**VALIDATION FINDINGS REPORT
FOR
GUIDANCE DOCUMENT
REASONABLE AND PRUDENT PRACTICES FOR STABILIZATION
OF OIL AND NATURAL GAS CONSTRUCTION SITES**

**Terracon Project No. 92067965
May 4, 2007**

Re: **Validation Findings Report**
Guidance Document Reasonable and Prudent Practices for
Stabilization of Oil and Natural Gas Construction Sites
Terracon Project Number 92067965

Table 3-22: Assumed Soil Type and Erodibility in GD-RAPPS Decision Trees

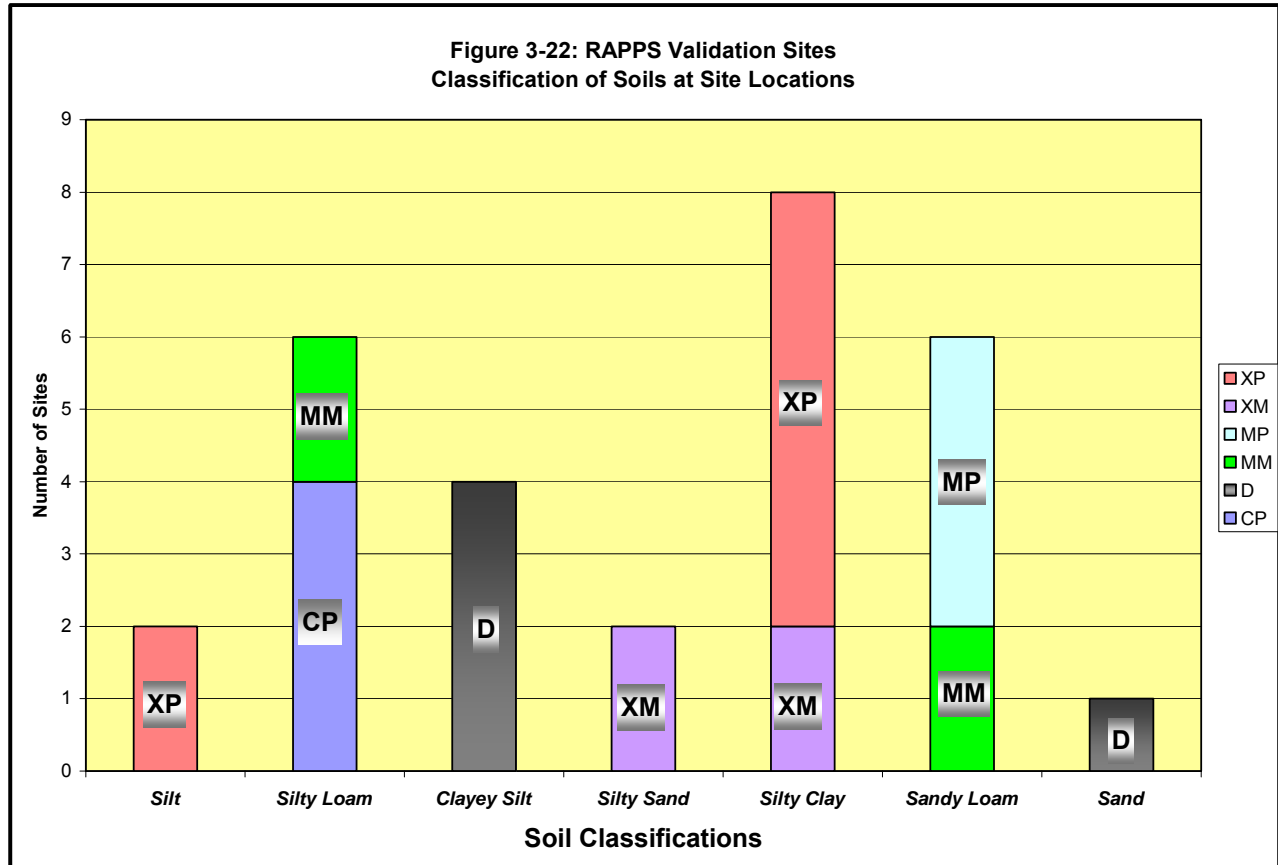
One of the six GD-RAPPS geographic regions (CP) was classified as having a highly erodible soil. Two regions (MP and MM) were classified with soils of moderate erodibility, and three regions were classified as having soils of low erodibility. Three of the RAPPS Decision Trees (D, XP and XM) are based upon the assumption that the soils of those regions can be classified as being of low erodibility. With the exception of the Coastal Plains areas and a small portion of Texas, these three regions (D, XP and XM) encompass the entire western United States. In essence, the GD-RAPPS is based upon the generalization that all the soils in the western United States are of low erodibility and recommends RAPPS accordingly. Of the remaining three regions for which a GD-RAPPS decision tree is available, two are characterized with soils of moderate erodibility (MM and MP) and one is characterized by a soil of high erodibility (CP).

Based on our analysis, the assumption that three of the six geographic regions in the continental United States exhibit low erodibility, appears to be an over-generalization.

The assumption on the MP decision tree that soils are moderately erodible without designating soil types is not sufficiently descriptive and may be misinterpreted by operators.

Numerous soil types were identified in the field validations as documented in Figure 3-22 and Table 3-2.

The field validations indicated 13 of 29 soil types (45%) matched the soil type and erodibility assumptions for the geographic regions. Based on our evaluation indicating less than half of the soil types or erodibilities identified during the site inspections were valid for the specific geographic region, the soil type assumptions in RAPPS may commonly be inaccurate. The document oversimplifies the soil types identified in each geographic region. Based on a review of the Natural Resources Conservation Service (NRCS Website, 2007) maps, most, if not all, soil types identified in GD-RAPPS could be found in each geographic region and are not specific to any one area.

In each of the 16 sites where the soil type or erodibility did not match the GD-RAPPS assumptions, the erodibility was under predicted potentially resulting in RAPPS that may not be appropriate or sufficient to reduce sediment loss due to storm water.

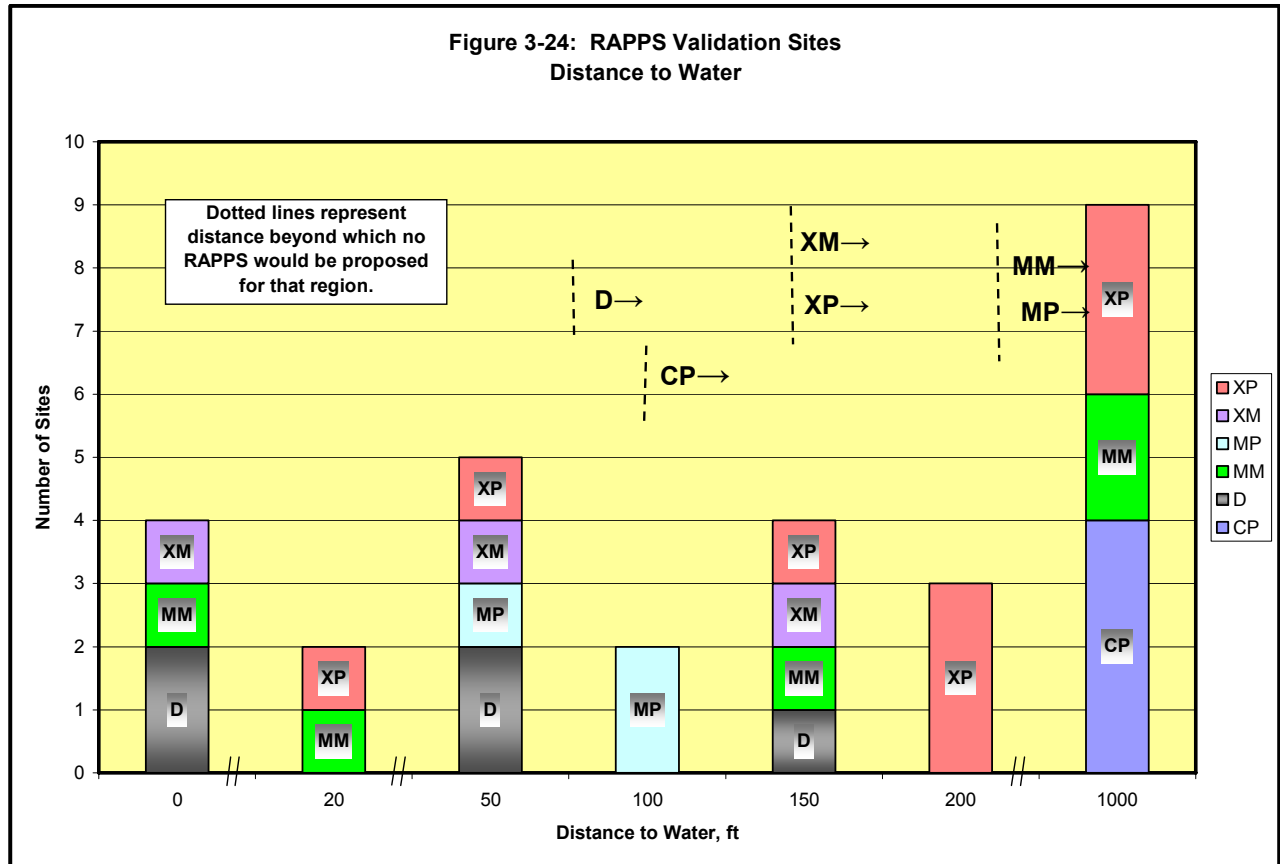
Figure 3-24 presents a summary of the distances to the closest waters that were observed during the site visits. Note, that most of the distances were not exact measurements, but approximations following the guidance in the GD-RAPPS.

At four of the sites, representing three different geographic regions, the distance to the water was zero because the well pad was constructed adjacent to a regulated water body or water had been diverted around the site.

Overall, the distance to water for eleven of the sites was less than 75 feet. In these cases, RAPPS would be recommended for the six geographic regions. The distance to water for eight of the remaining sites was greater than 1,000 feet. At this distance no RAPPS would have been recommended for the six geographic regions.

Of the remaining nine sites, four of the sites (one D and three XP) were farther than the minimum distance for that geographical region (no RAPPS), while five of the sites were at or below the minimum GD-RAPPS distance (with RAPPS recommended).

The field validations indicated that RAPPS were required by GD-RAPPS for 12 of 29 construction sites indicating the inspector used the decision tree process 41% of the time due to the distance to water. Terracon inspectors recommended RAPPS at 24 of 29 construction sites (83%), which included the five planned sites where construction activities had not commenced. The operators installed at least one of the RAPPS documented in Appendix A of GD-RAPPS at 24 of 24 construction sites (100%). It should be noted that five sites were in the planning stage, and construction had not commenced; therefore, a total of 24 sites were evaluated where RAPPS could have been installed. The discrepancy between the number of RAPPS installed by operators and the number of RAPPS recommended by Terracon was due to five sites in Texas where RAPPS were not recommended by Terracon. Our evaluation indicates that 41% of the time, an operator would have installed RAPPS based on the GD-RAPPS decision trees compared to Terracon recommending RAPPS 83% of the time. This indicates that the minimum distance to water assumptions may be too short, and the distance to water assumptions should be evaluated.

Distance to water has historically not been used as a factor in evaluating storm water RAPPS, and, if used, the distances documented in RAPPS may not be sufficiently protective of waters of the U.S. Based on our literature search, evidence indicates that once sediment is detached and leaves the site, it may be transported for significant distances and deposited in waterways (USDA, 2001). Although sediment may be filtered and captured by vegetation downgradient of the site, six field validations indicated that sediment had been eroded from the site, and in one case had been deposited in a nearby waterway. This may be due to eroded material being initially captured by vegetation and subsequently transported to a waterway during a high intensity rain event.

The RAPPS document is vague regarding how the nearest regulated water body is determined. The decision trees reference the distance to water, whereas the document text refers to regulated water bodies, which include waterways that may be seasonally dry. This discrepancy may result in the distance to “live water” being confused with waters of the U.S. by oil and gas operators in the field. During five site verifications (Table 3-21), the operator and the site inspector used significantly different distances to water to evaluate RAPPS options because they interpreted water bodies differently. Based on our field validations, operators may misinterpret “distance to water” in the decision trees, which includes waterways that may be seasonally dry.

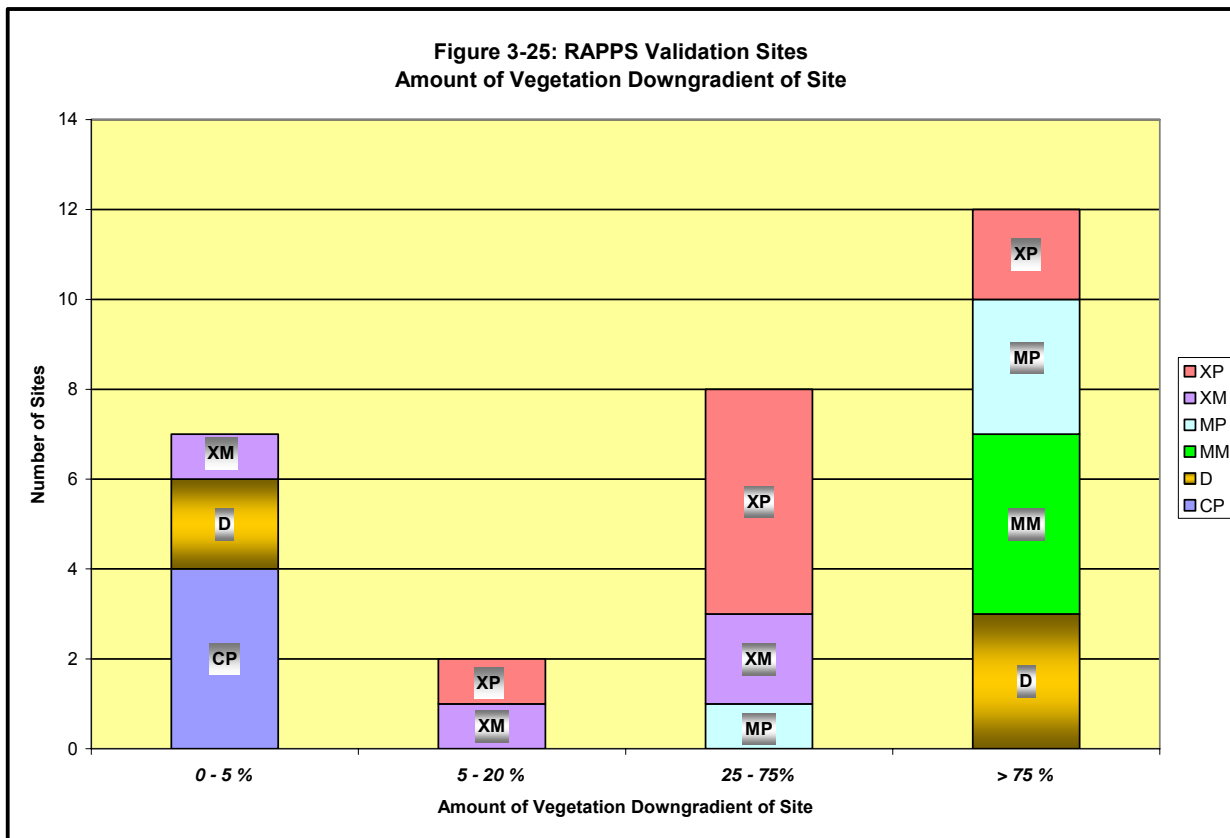
A summary of the amount of vegetation observed in downgradient positions from the sites is presented in Figure 3-25.

The field validations indicated that 14 of 29 sites (48%) had greater than 75% vegetative cover in downgradient positions from the site, while six of 29 sites (21%) had less than 5% vegetative cover. It should be noted that the site inspections were conducted in the fall and winter, and the amount of vegetative cover may have been underestimated in some cases, since the vegetative cover

percentage was determined from the vegetation stem structure, even if the green portion of the plant had died. However, in some cases, vegetative cover may have been overestimated because of the tendency of some people to estimate vegetative cover by looking down at the canopy rather than evaluating and estimating the percent of structure (i.e. stems) at the soil level that serves to filter sediment. Those sites that were located in cultivated farmland (CP sites) were reported as having no vegetative cover since the plants had been plowed under.

The Desert geographic region's assumption that vegetative cover is less than 25% was evaluated by comparing the amount of vegetative cover observed in the five Desert sites. Based on the field inspectors and operators evaluation of vegetative cover, three of the Desert sites exhibited greater than 75% vegetative cover, while two of the five sites exhibited five percent or less of vegetative cover. Our evaluation indicates that the vegetative cover assumption may be invalid, and varying vegetative cover percentages could be found in the Desert geographic region or the other geographic regions
